Drury Metropolitan Centre Fast-track

Auckland Council Specialist Memo

Urban Design Memo

1. This memo provides a review of the urban design aspects of Stage 1 (residential subdivision) and Stage 2 of the Drury Metropolitan Centre Fast Track Application. The application has been made to an Expert Consenting Panel under the Fast-track Approvals Act 2024 ('FTAA') and in terms of the Auckland Unitary Plan (Operative in Part) 'AUP:OP'.

Figure 1:
Recommended road Connections to eastern site boundary of Stage 2

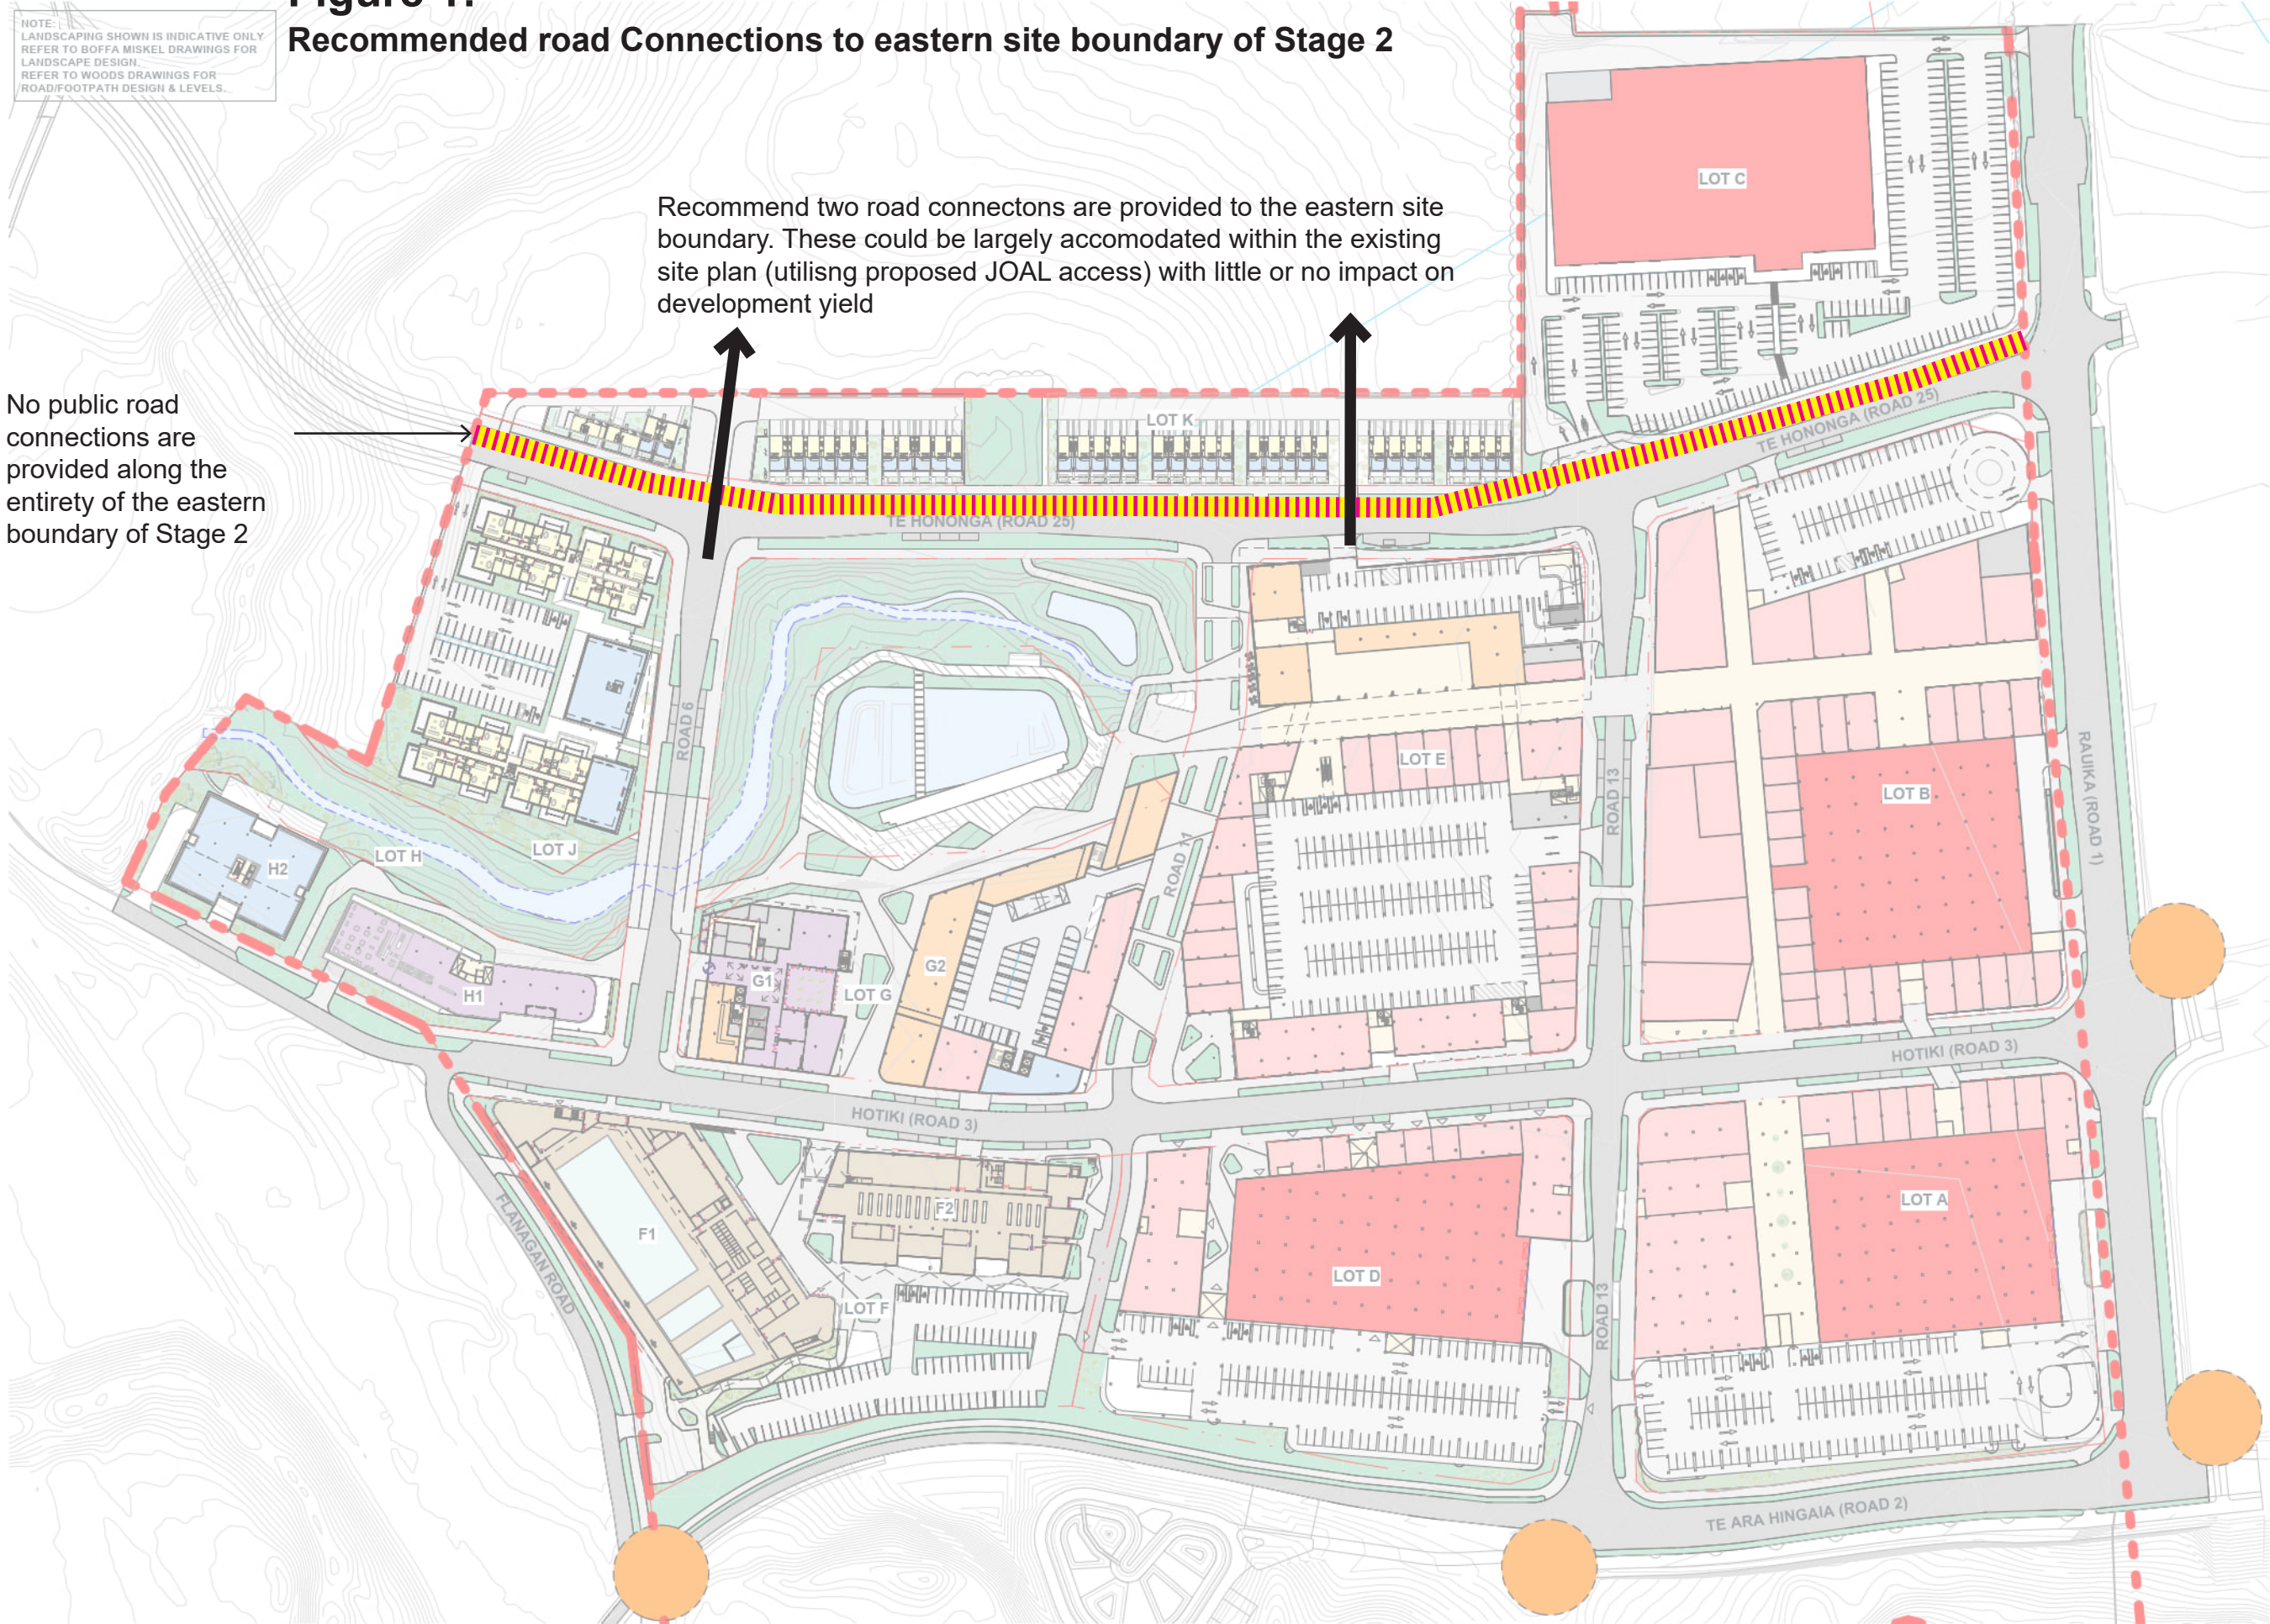
12. It is recommended that Road 6 be fully formed and extended to the eastern site boundary as part of this fast-track application to provide certainty for neighbouring landowners. It is also recommended that a second road connection occur further south within Lot K between Road 11 and Road 13. Refer to **Figure 1** attached to this memo.

No public road
connections are
provided along the
entirety of the eastern
boundary of Stage 2

Recommend two road connectons are provided to the eastern site
boundary. These could be largely accomodated within the existing
site plan (utilising proposed JOAL access) with little or no impact on
development yield

- a. It is recommended that Road 6 be fully formed and extended to the eastern site boundary. It is also recommended that a second road connection to the eastern site boundary of Stage 2 occurs further south within Lot k between Road 11 and Road 13. Refer to **Figure 1** attached to this memo.

Prior to construction commencing, the consent holder must submit drawings to the Council which detail the extension and construction of a fully formed public road at the following locations and as indicated in **Figure 1** of this memo:

- Eastern side of Road 6 and Road 25 intersection directly to the eastern site boundary that continues the alignment of Road 6.
- A public road connection to the eastern site boundary within Lot K.

The above roading must be constructed at the above locations prior to the construction of any dwellings on lot k.

Figure 2:
Lots recommended to have store front pedestrian access to a public street in addition to any secondary pedestrian access from a covered pedestrian lane or internal car park

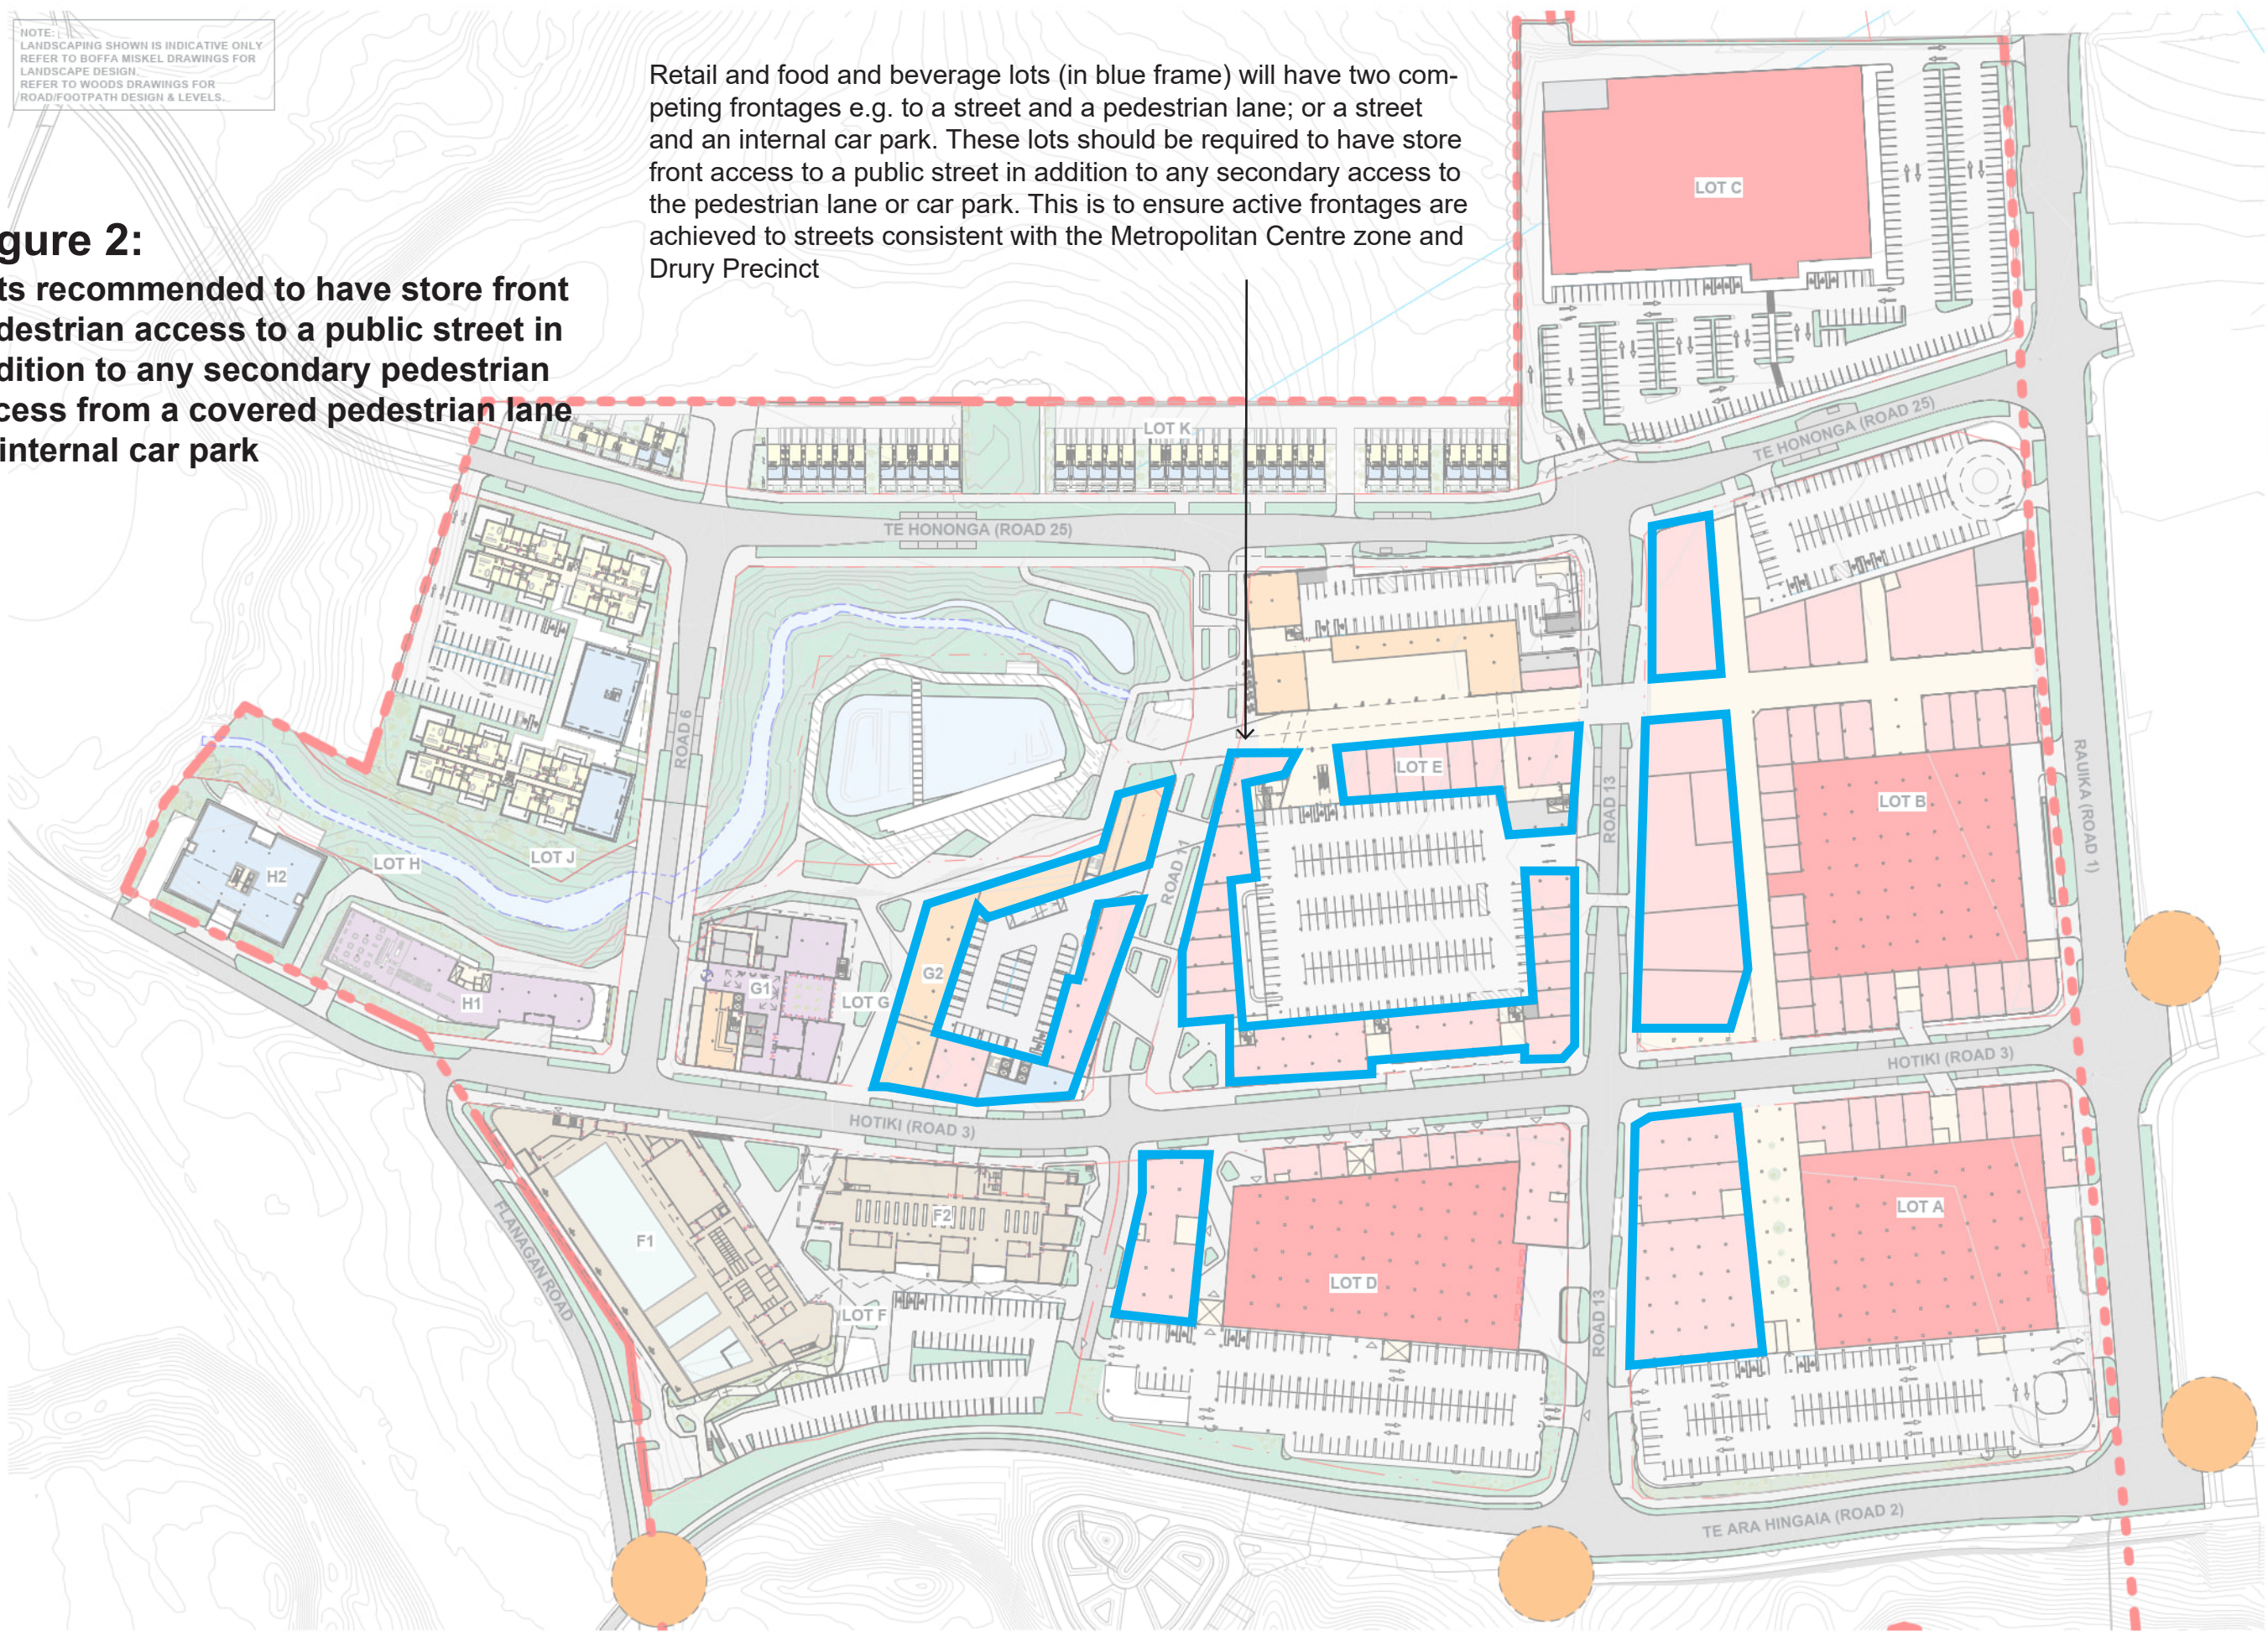
15. To ensure that building activation and engagement with the street is realised, it is recommended that a condition of consent require all lots that have frontages to both a street (public or private) and a covered pedestrian accessway or car park; ensure pedestrian access is provided to a store front door which opens out directly to the street during opening hours. This could be in addition to any secondary access which may be provided to that store from the covered pedestrian accessway or car park. Refer to **Figure 2** attached to this memo which identifies the affected lots.

Retail and food and beverage lots (in blue frame) will have two competing frontages e.g. to a street and a pedestrian lane; or a street and an internal car park. These lots should be required to have store front access to a public street in addition to any secondary access to the pedestrian lane or car park. This is to ensure active frontages are achieved to streets consistent with the Metropolitan Centre zone and Drury Precinct

- b. To ensure that building activation and engagement with the street is realised, it is recommended that a condition of consent require all lots that have a frontage to a street (public or private), ensure access is provided directly from the street to the store front during opening hours. This could be in addition to any secondary access which may be provided to that store from a covered pedestrian accessway or internal car park.

Prior to construction commencing, the consent holder must submit evidence that building access for pedestrians to the store front on the dual fronting lots identified in **Figure 2** of the urban design memo, will be prioritised from the adjoining street during store opening hours.
